### World Forum for Harmonization of Vehicle Regulations

### Working Party on Passive Safety

Geneva, 16–20 May 2011

## Report of the Working Party on Passive Safety on its forty-ninth session

Figure 1  
Positioning requirements for side-facing seats

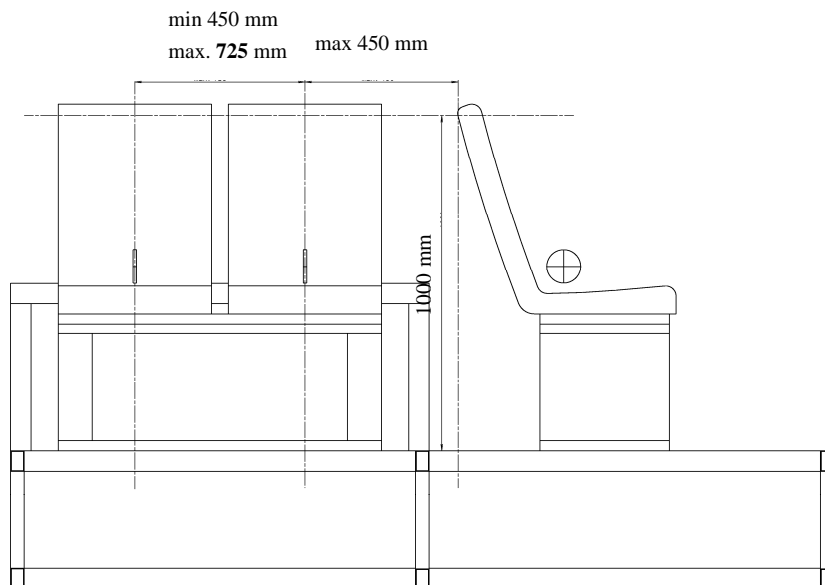
#### Amendments adopted to ECE/TRANS/WP.29/GRSP/2010/36 (see para. 29 the report)

*Insert a new Appendix 7, to read:*
